D117-762-011
Job Sheet 192989

Part Name: Skidtube with Standard Wearplates Fits LH or RH

DART SERVICE INSTRUCTION

TO AMEND INSTALLATION INSTRUCTIONS IIN-D117-762 REV. E AND
INSTRUCTIONS FOR CONTINUED AIRWORTHINESS ICA-D117-762 REV. 4

FIGURE 1 - GHL UPGRADE INSTALLATION

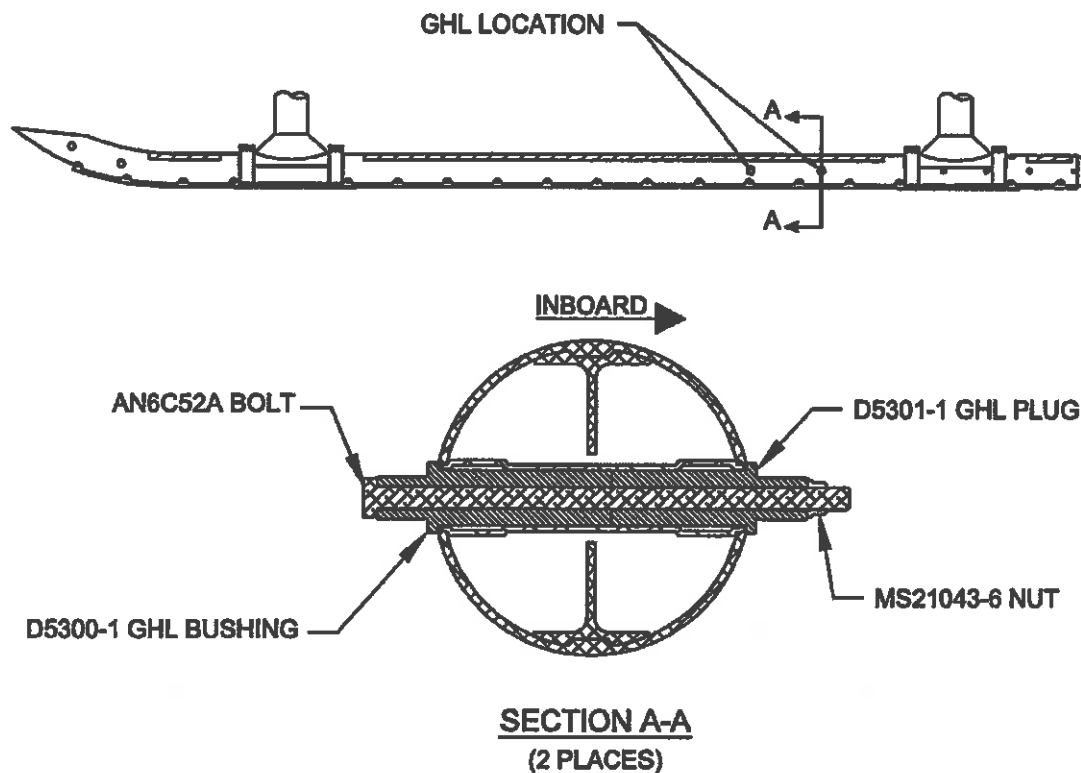
The purpose of this Dart Service Instruction (DSI) is to replace the ground handling lugs (D3864-1 Bushings, AN6C51A Bolts and MS21043-6 Nuts) on the D117-762-XXX Skidtubes with a structurally superior lug design (D5300-1 Bushings, D5301-1 Plugs, AN6C52A Bolts, MS21043-6 Nuts) as shown in Figure 1. The new hardware will be included in D117-762-011 @ CHG 004 and subsequent.

- 2.1 Loosely install (qty 2) D5300-1 GHL Bushing & (qty 2) D5301-1 GHL Plug wet with Proseal 890 or MIL-S-8802 Class B2 Sealant in location shown in Figure 1.
- 2.2 Install (qty 2) AN6C52A Bolts and (qty 2) MS21043-6 Nuts in accordance with Figure 1. Clean up squeezed out Proseal and apply fillet seal around D5300-1 & D5301-1.
- 2.3 Torque AN6C52A Bolts 160 - 190 in-lbs (18.1 - 21.5 N-m).

ITEM	QTY -011	PART NUMBER	DESCRIPTION
	X	D117-762-011	SKIDTUBE INSTALLATION
50	2	AN6C52A	BOLT
51A	2	D5300-1	GHL BUSHING
51B	2	D5301-1	GHL PLUG
52	2	MS21043-6	NUT
